REVISED RESPONSE TO REQUEST FOR ADDITIONAL INFORMATION

APR1400 Design Certification

Docket No. 52-046

RAI No.: 38-7878
SRP Section: 07.05 – Information Systems Important to Safety
Application Section: 7.5
Date of RAI Issue: 06/18/2015

Table 7.5-1 (1 of 5)

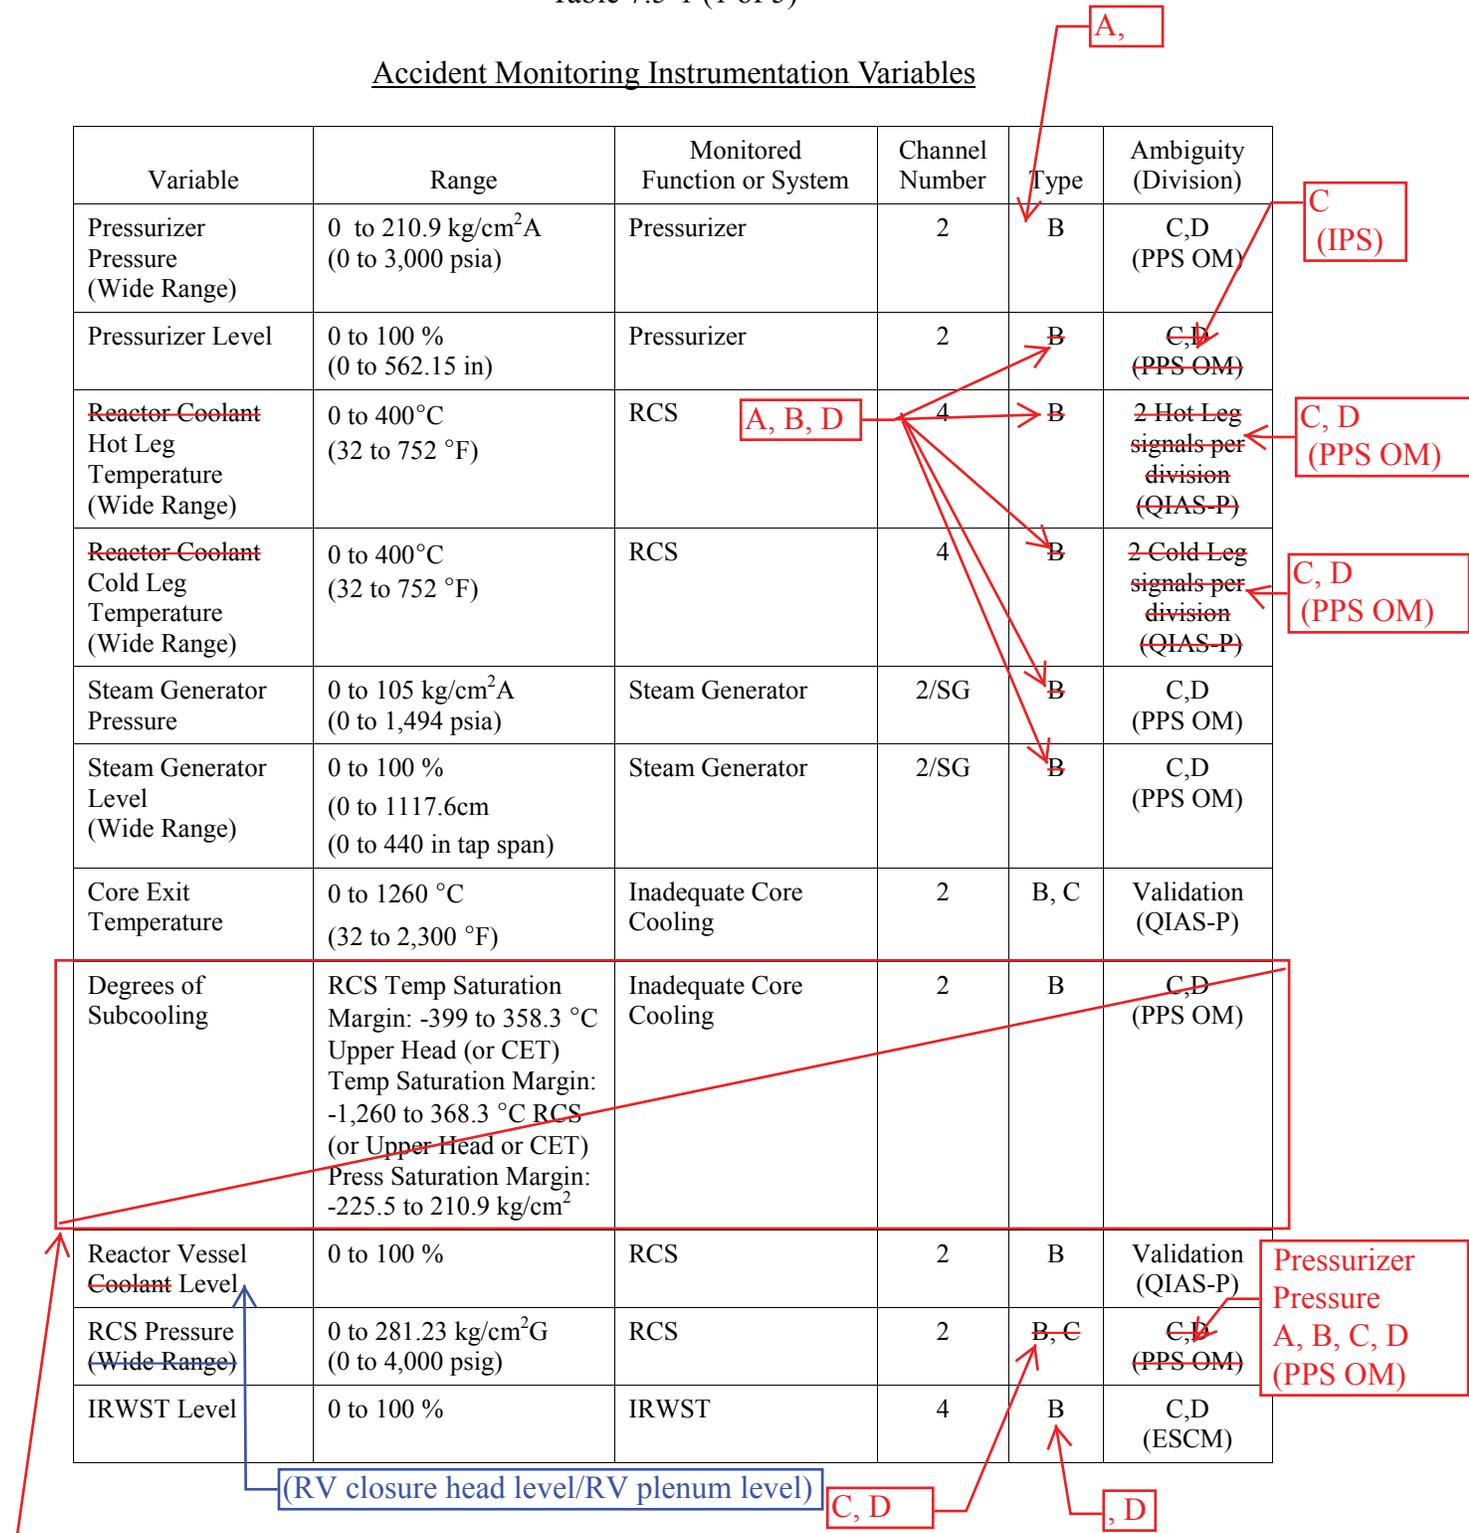
APR1400 FSAR Tier 2, Section 7.5.1.1 does not provide the basis or analysis for the selection of the accident monitoring instrumentation (AMI) variables.

To be revised as shown on the next page.

Figure 7.5-1 Diverse Display of Accident Monitoring Type B and C Variables

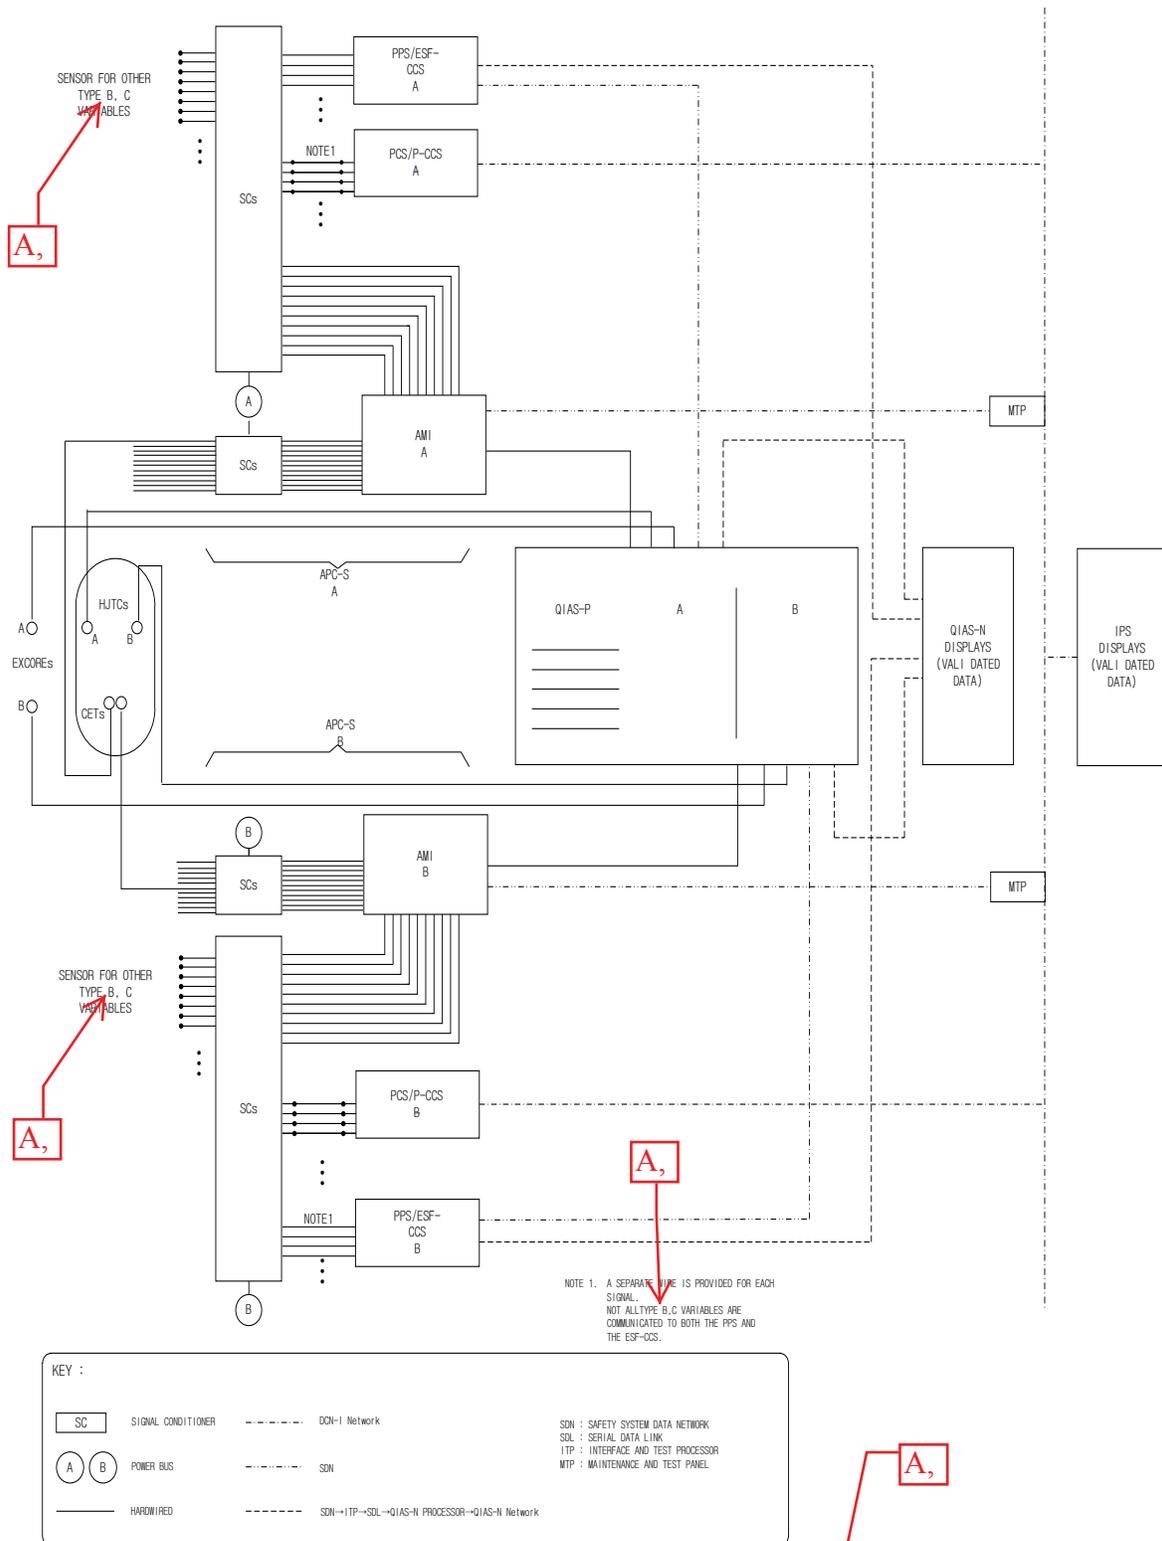
The AMI is designed to meet the guidance of NRC Regulatory Guide (RG) 1.97 (Reference 1), as depicted in Figure 7.5-1 and as follows:

- a. The qualified indication and alarm system - P (QIAS-P) is dedicated to continuously monitor and display AMI Type B and C variables. ~~There are no AMI Type A variables in APR1400 design.~~ The QIAS-P in each division (A or B) has one flat panel display, which is mounted on a safety console in the MCR.
- b. The qualified indication and alarm system - non-safety (QIAS-N) is designed to support continuous plant operation if the information processing system (IPS) becomes unavailable. The function of the QIAS-N also includes displaying AMI Type B, C, and selected sets of Type D and E variables.
- c. The IPS provides displays for all AMI variables. The IPS also has a historical data storage, retrieval, and trending capability.

Figure 7.7-12 HSI Information Processing Block Diagram

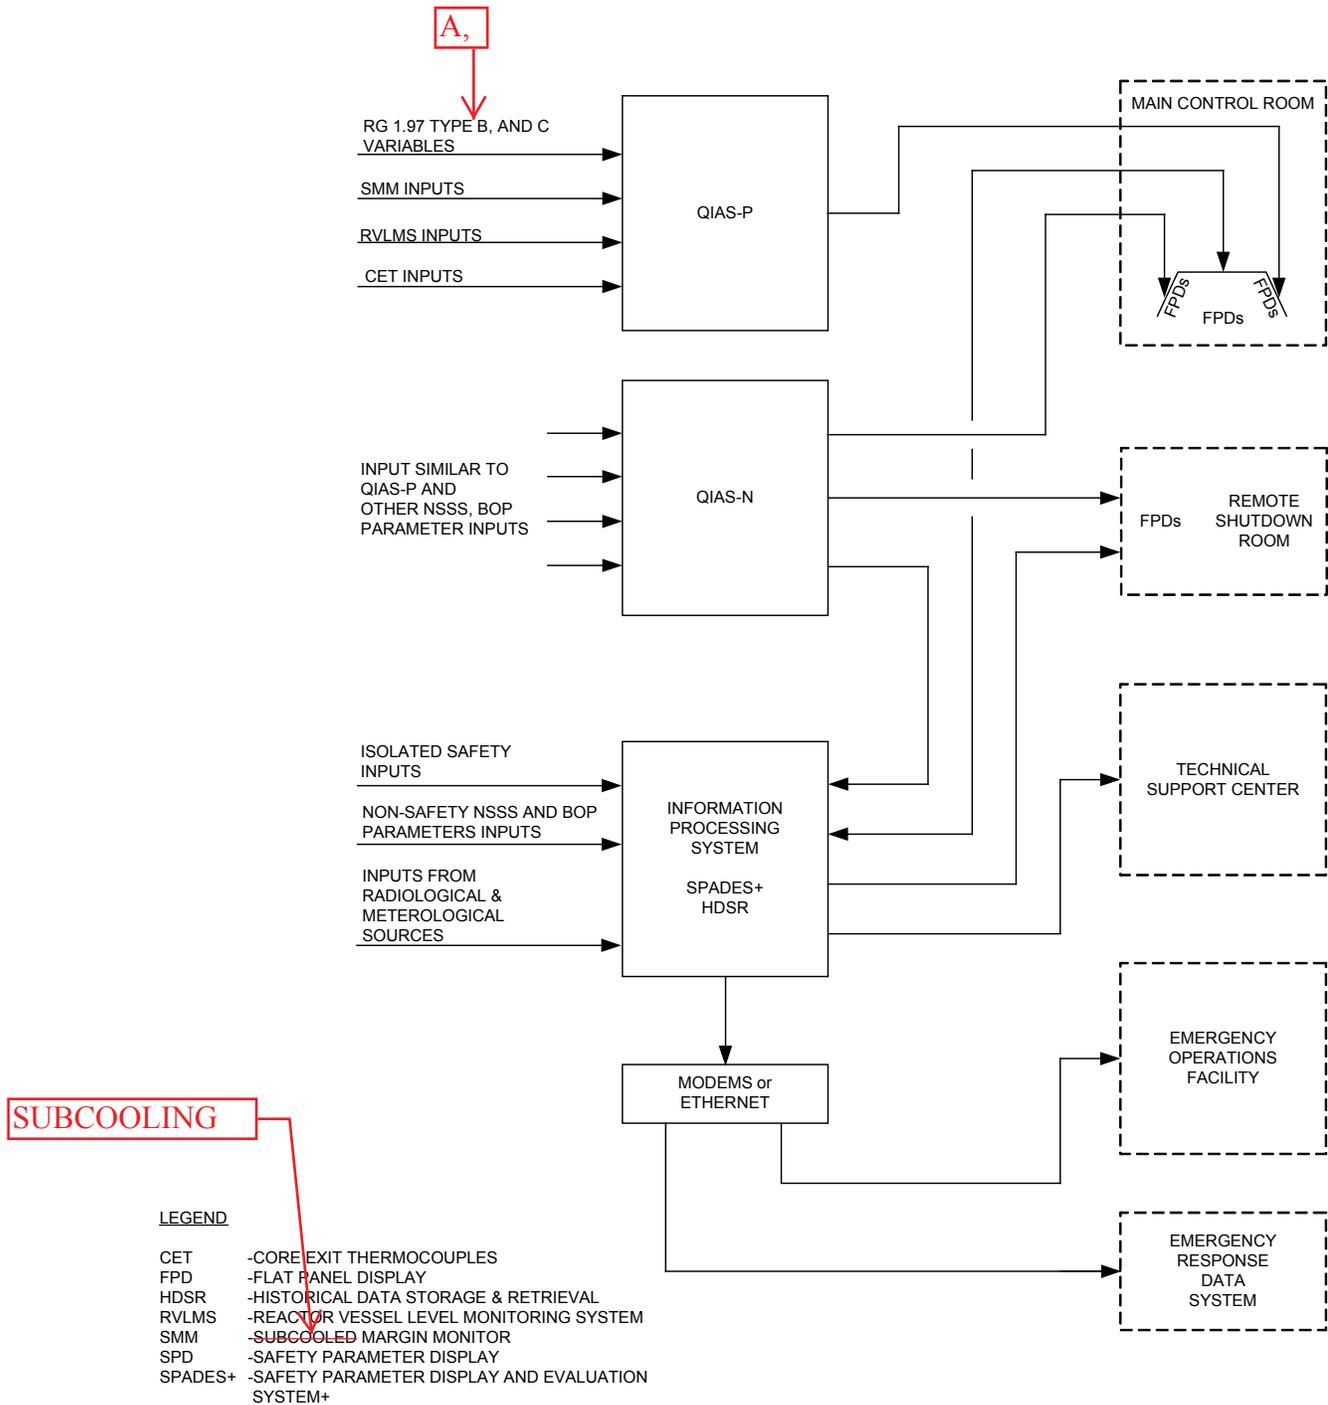
SUBCOOLING
